City of Sebastopol Design Review Board Staff Report

Meeting Date: March 3, 2021
Agenda Item: 8A
To: Design Review Board
From: Alan Montes, Associate Planner
Subject: Design Review for Oxygen Storage Tanks
Recommendation: Conditional Approval
Applicant/Owner: James Loera/Gurpreet Singh
File Number: 2021-001
Address: 6789 Walker Ave.
CEQA Status: Categorical Exemption: Section 15303: Class 3
General Plan: Commercial Office (CO)
Zoning: Commercial Office (CO)

This is a design review application for the installation of oxygen storage tanks and screening in the parking lot located 6789 Walker Ave. to serve Sebastopol Specialty Hospital.

BCK #1

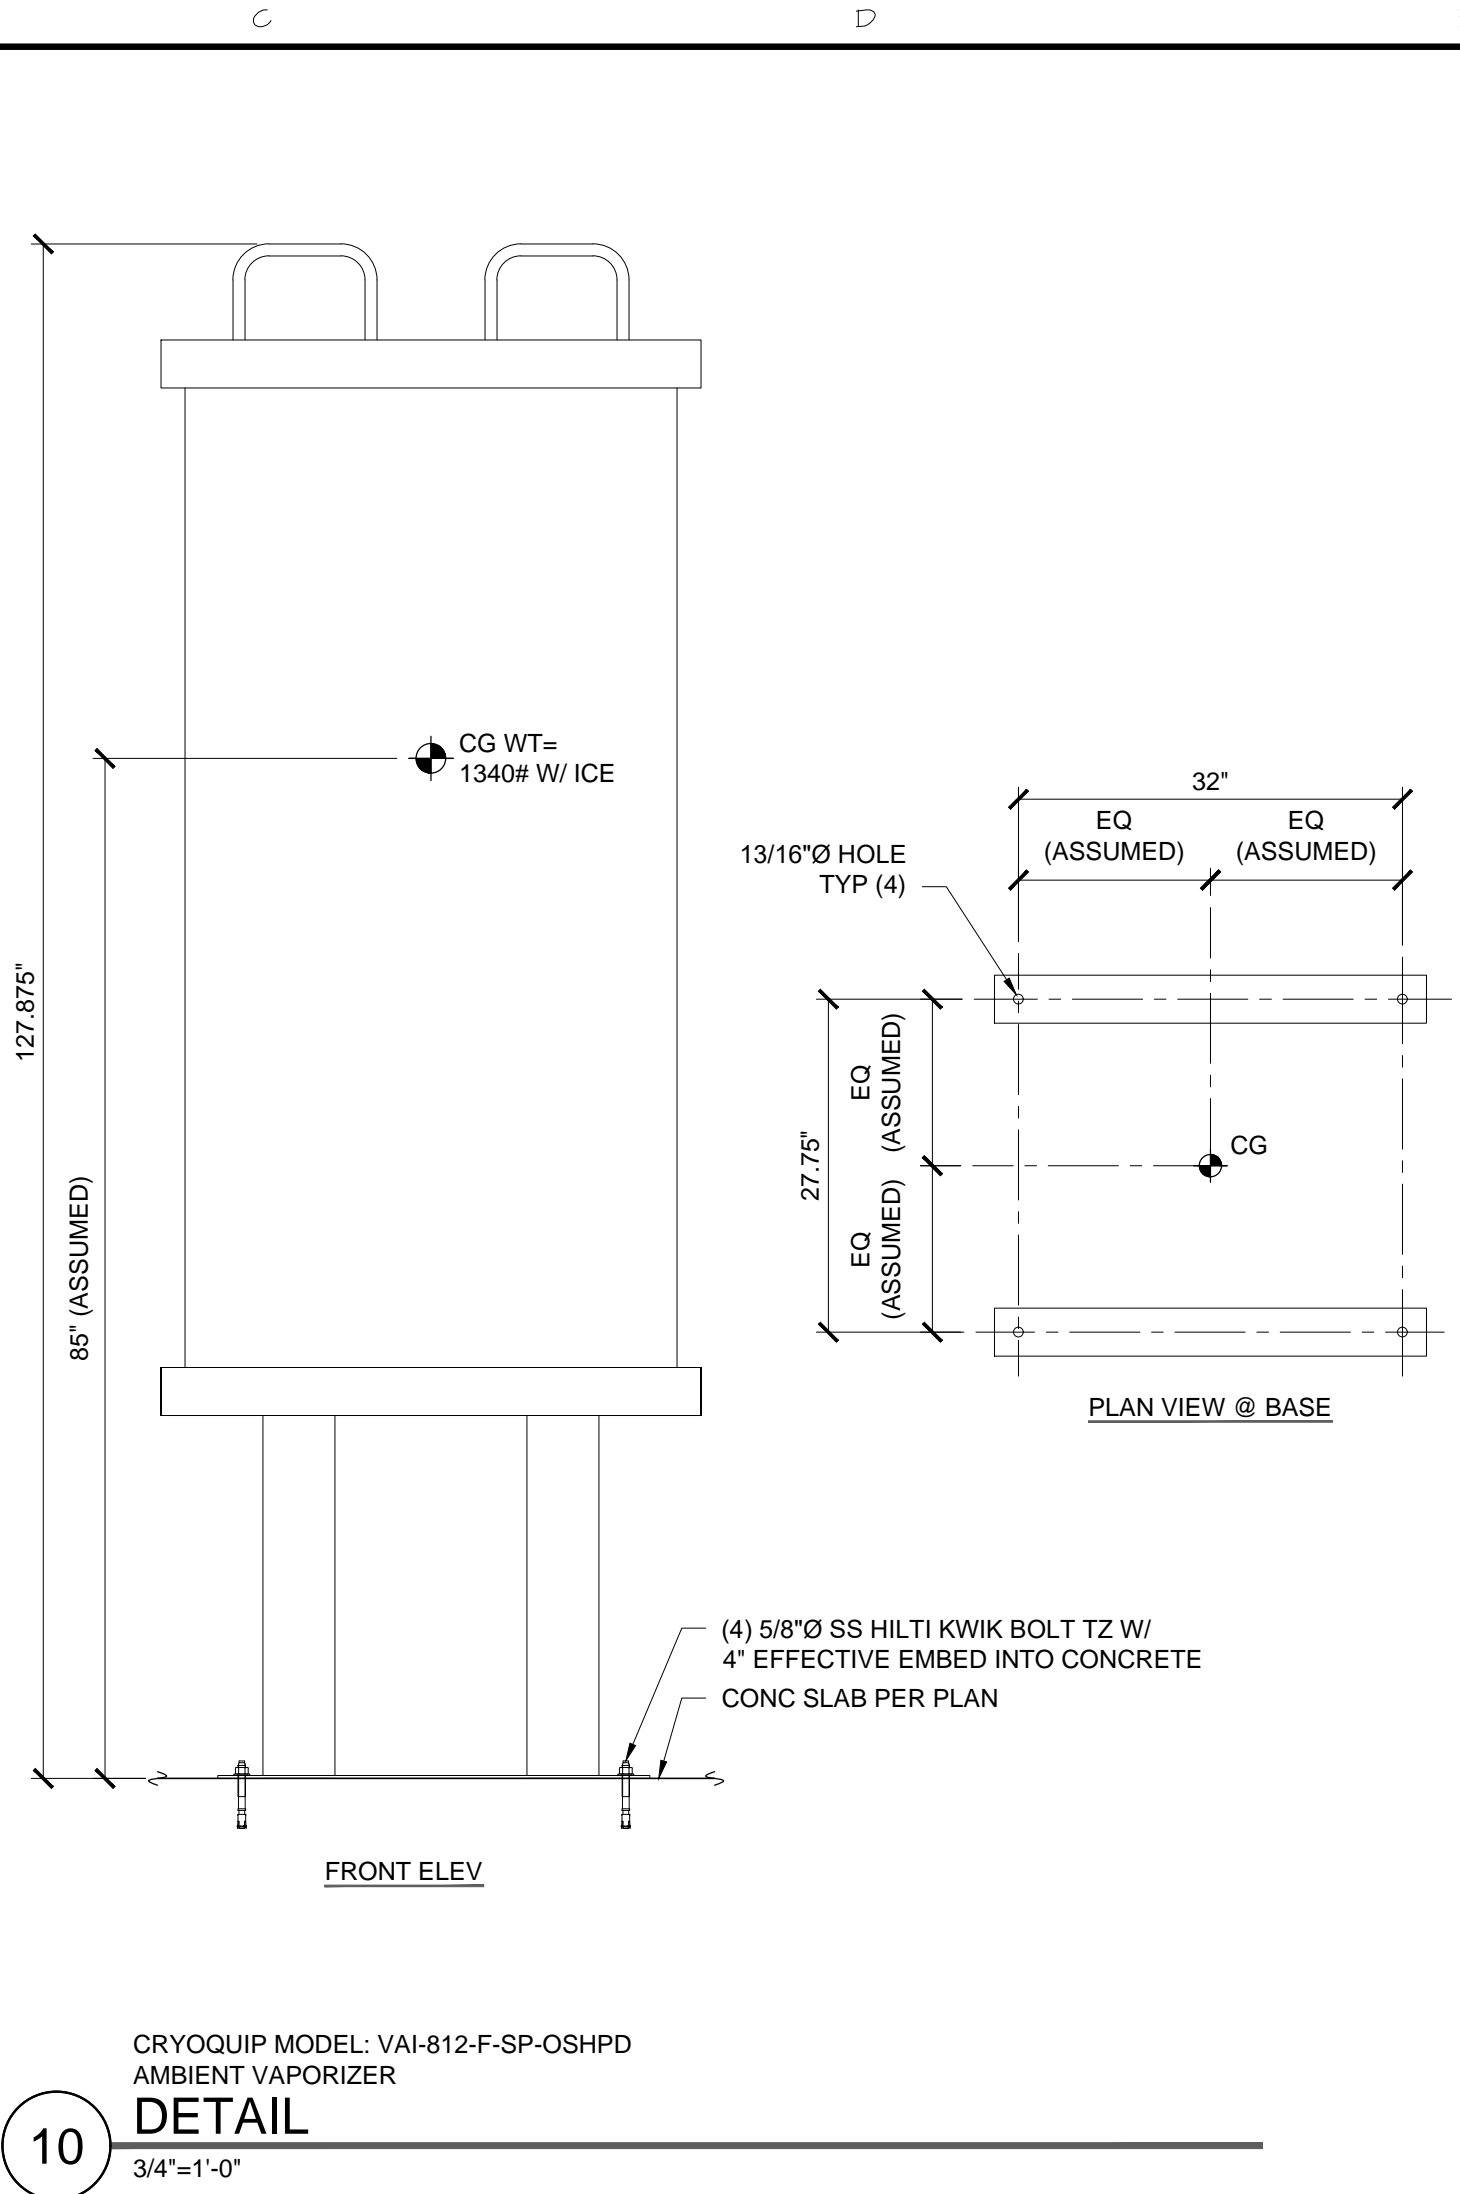
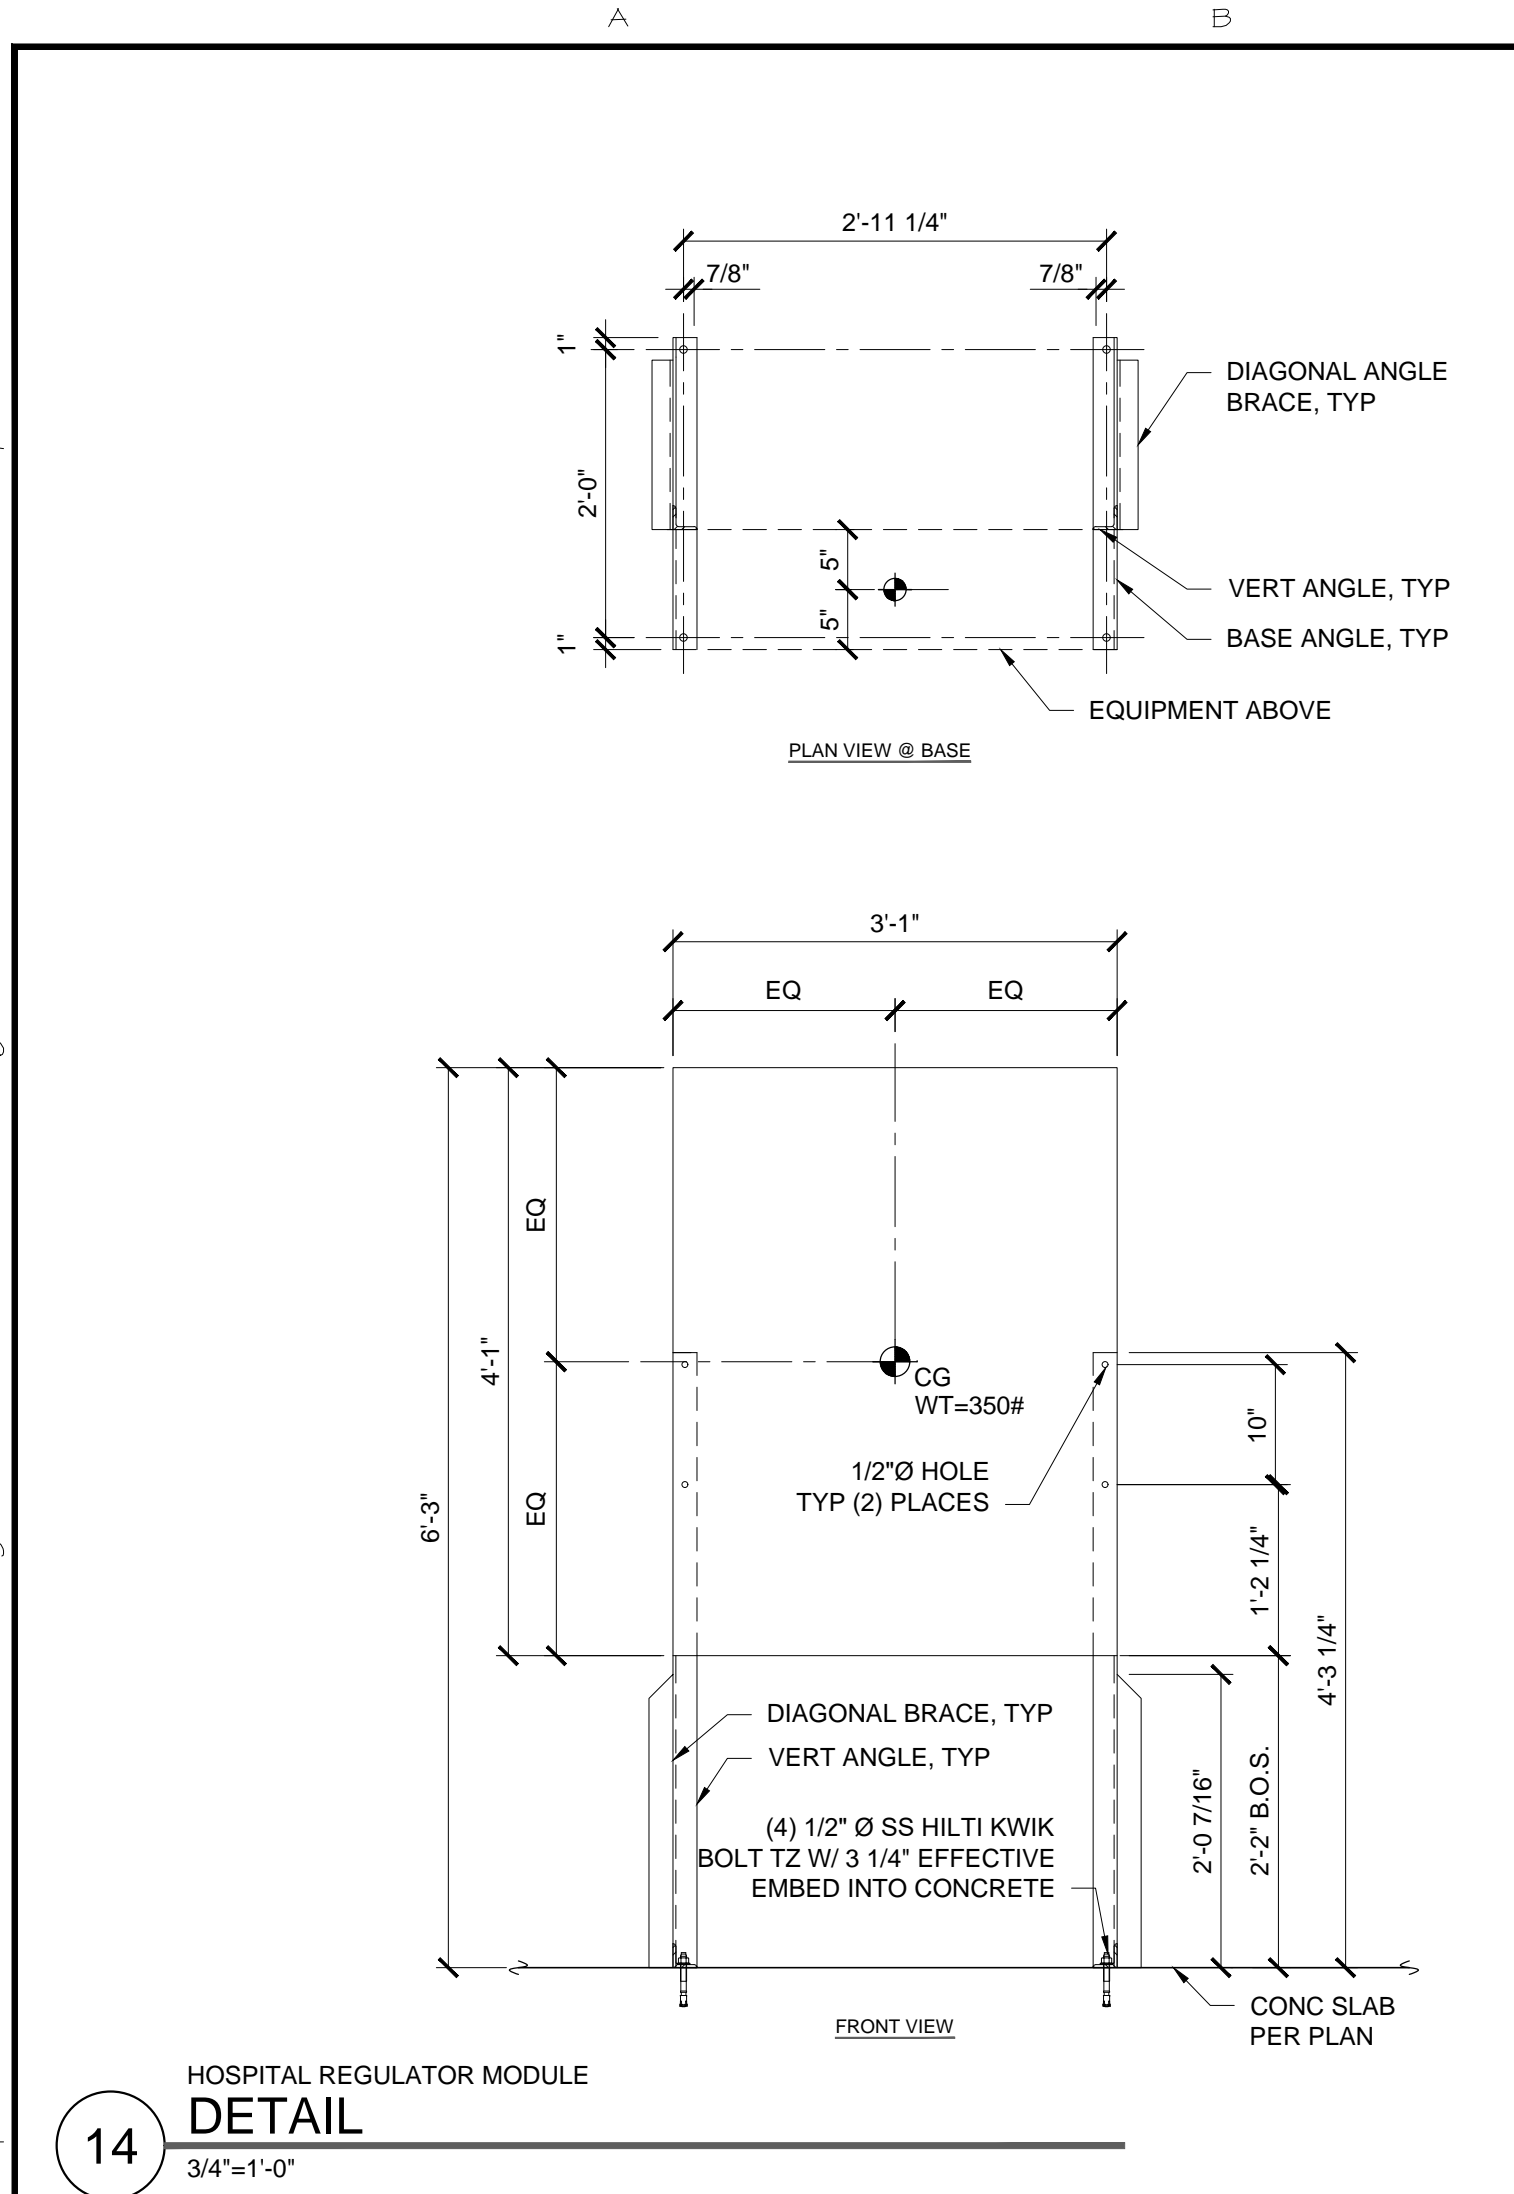
There is concern regarding the height of the structure and the screening material (chain link fence with slats). The storage tank does exceed the accessory structure height limit, but there is an exception to exceed the height limit by up to five feet for gas storage tanks. The project proposes a seven-foot chain link fence with slats around the equipment. The fencing will provide a partial screen along with the existing landscaping. Given that the equipment is located uphill from the right of way, staff anticipates minimal visual impacts from the street.

Staff is seeking the Board's input on whether a higher quality fence and/or a landscape island with root barriers should be added to the west of the equipment to better screen the equipment. The applicant has stated that oxygen yards typically utilize chain link fencing or CMU block walls for screening as they are non-combustible materials. Alternatively, if the Board is supportive of a chain link fence with slats, does the Board have a preferred color for the slats.

Thanks for getting this over to me. I had a chance to review the plans and given the overall height of the structure this will require the Design Review Board's review and approval. I apologize for the confusion, when we first spoke, without viewing plans, I was foreseeing a much smaller structure that could be entirely screened and in a less visible location.

1. Elevations showing the tanks + structures with the fence around it.
2. # of beds in the hospital
3. Fee = \$535 (I can take this in today over the phone, please confirm a time to call in via email)

Hi Alan – here are the elevations – sheet A-201 attached. Please note that the previous oxygen tank for the facility was at the SE corner at bottom of hill on access road around back. In 2015 they replaced the tank with large cylinders because the oxygen vendor trucks were not able to access that road. They could only provide the cylinders. They are having shortages with this capacity, especially in light of the COVID pandemic and added need for ventilators. The location selected for this project is the further “back” we could put this tank, and still have it accessed by the vendor’s supply trucks.
